**REQUEST FOR PROPOSAL RFP 22-0325
HQ RENOVATION SERVICES**

ADDENDUM #002

Issue Date: May 11, 2022

EXHIBIT B ASBESTOS CONTAINING MATERIALS (ACM) LOCATION DRAWINGS

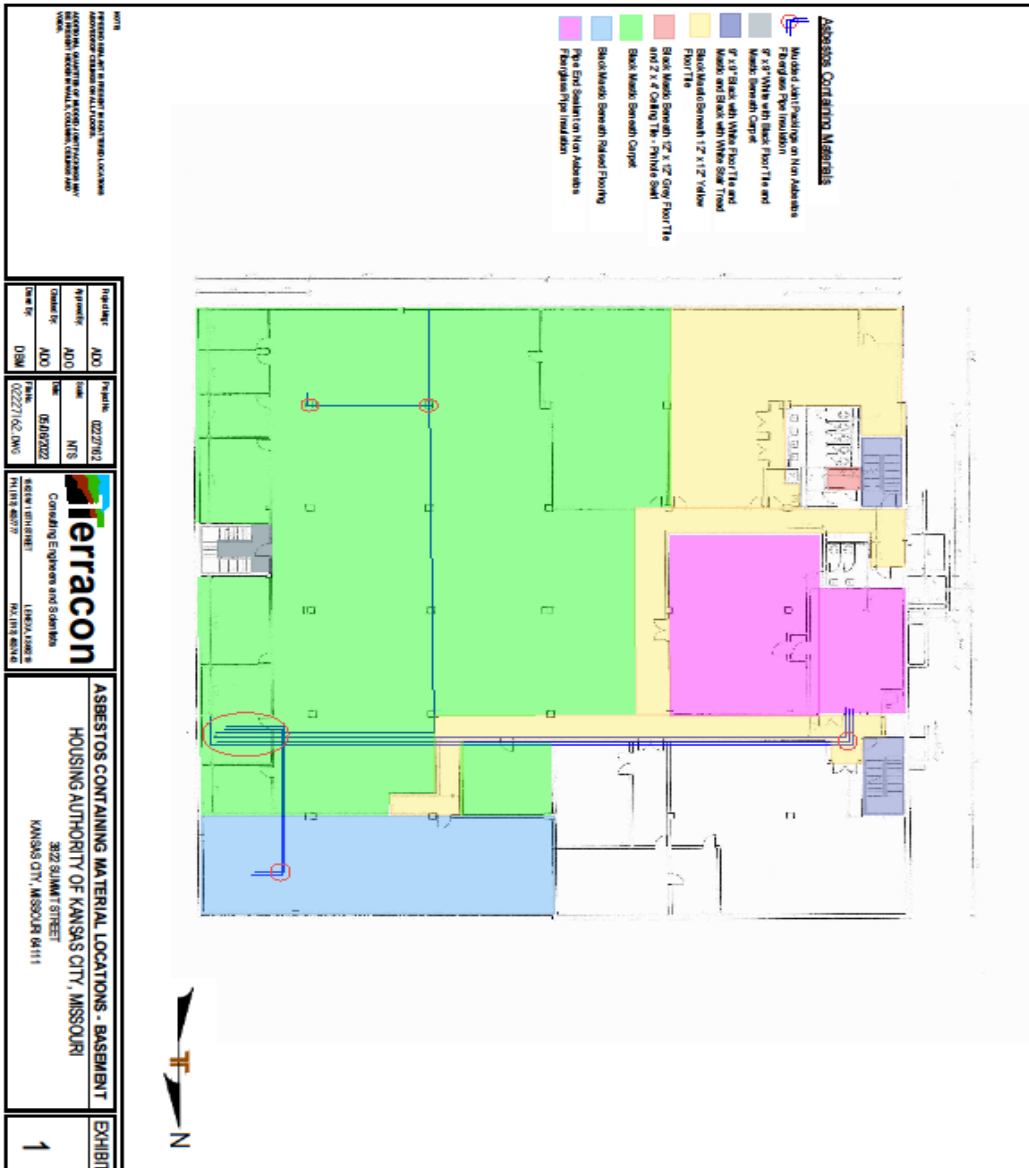
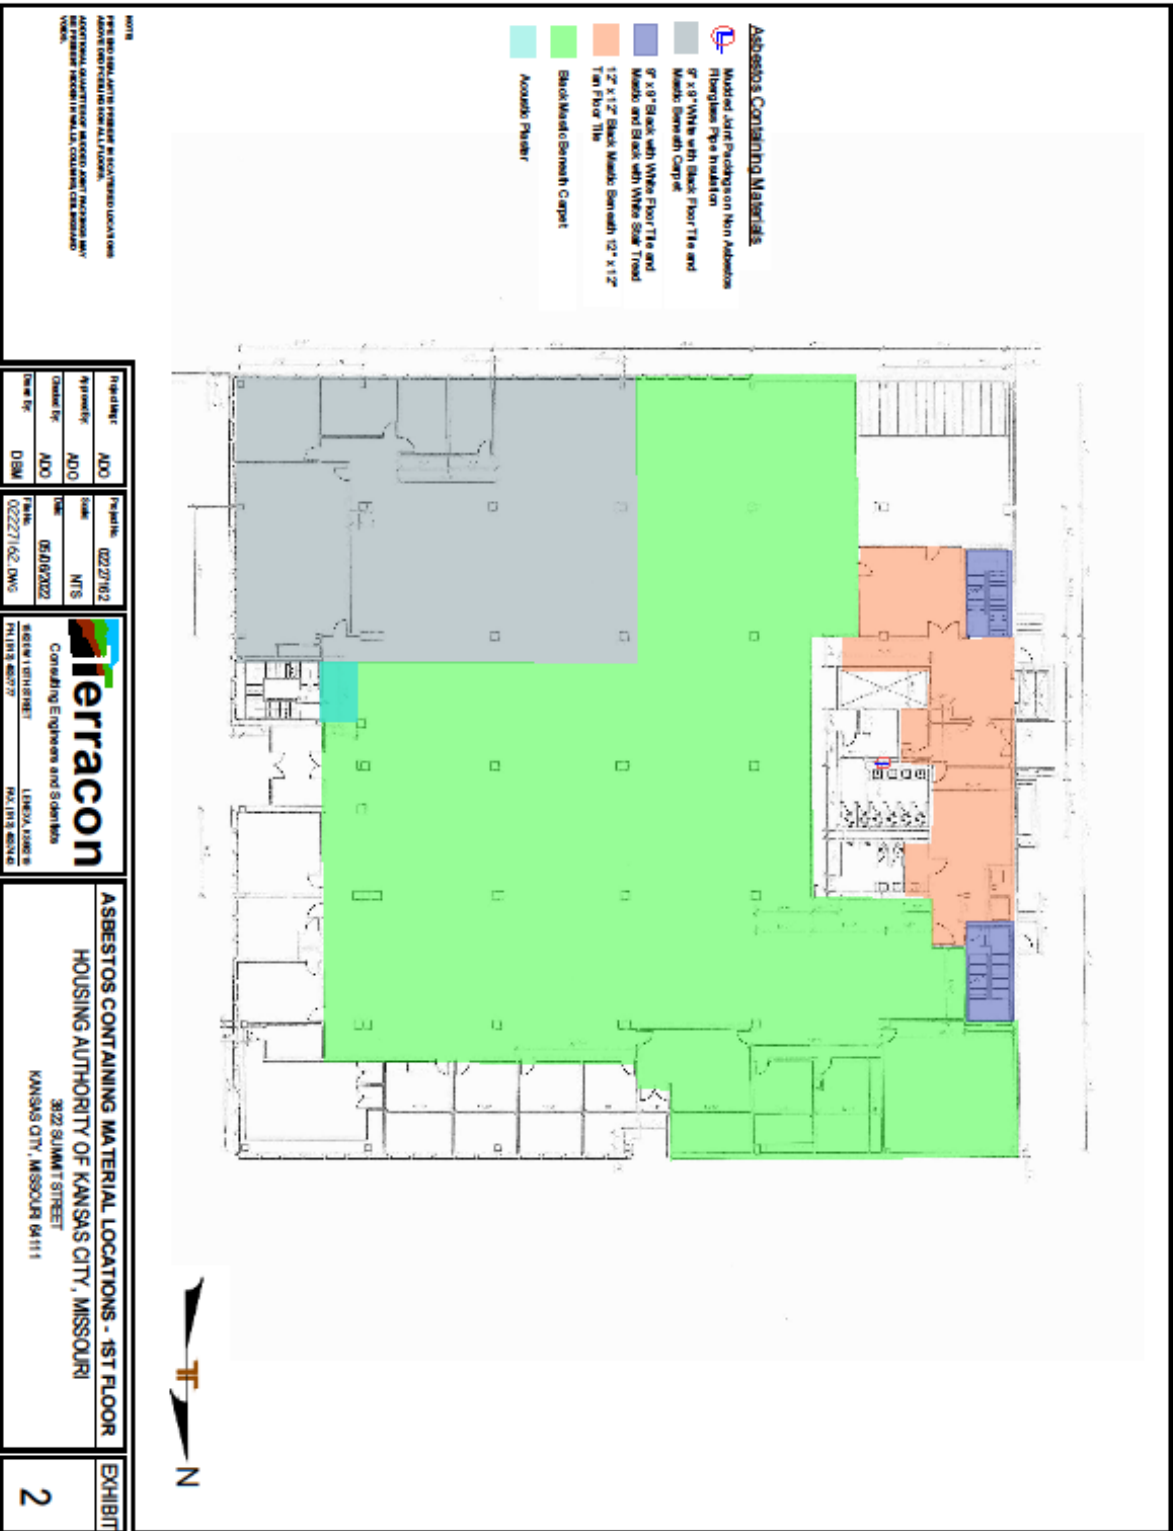
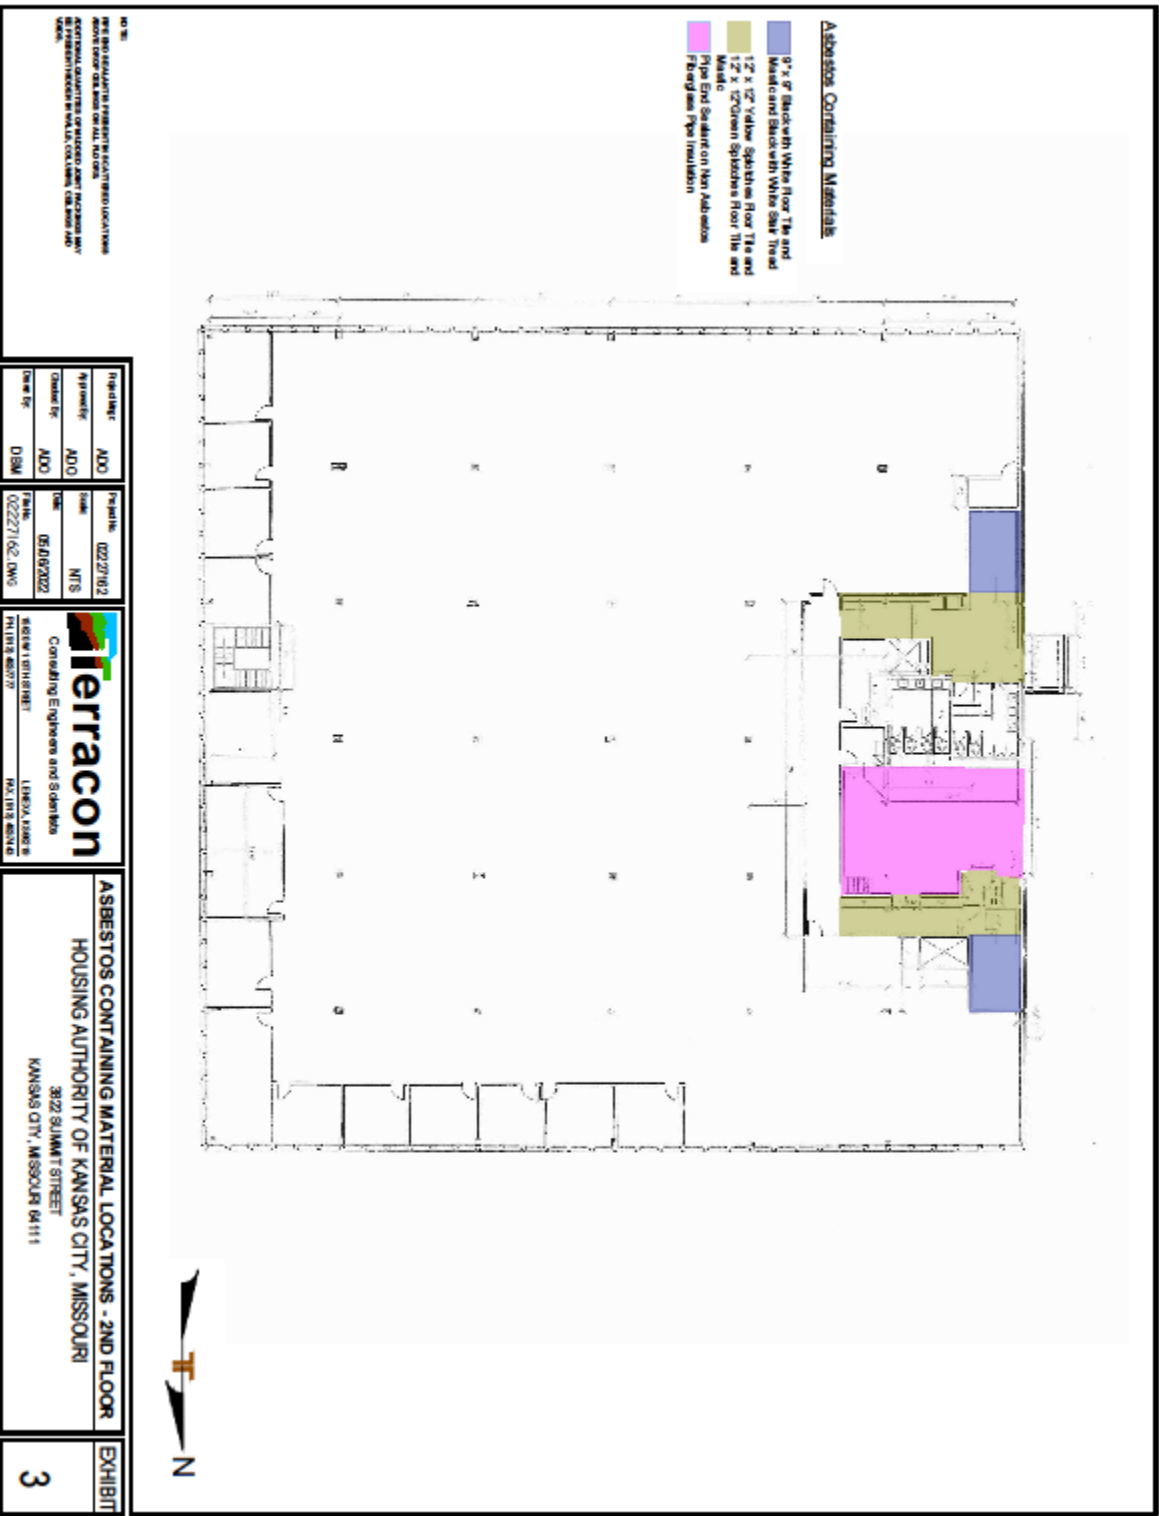
- A. This is acceptable.**
13. Q. In the report provided by Terracon there is not a drawing showing what areas need to be abated. The report tells us that there is asbestos in the floor adhesive but it's not in all of the floor. If you can please provide the drawing that identifies the locations of the hotspots from Terracon we would be able to bid the abatement more effectively.

- A. Please see Exhibit B on report from Terracon for the asbestos location drawings.**
14. Q. The drawings show stair treads to be replaced in 1 of the 3 stairwells. After meeting with HAKC we were under the impression that all stairs were to receive new treads. Can you please Clarify?
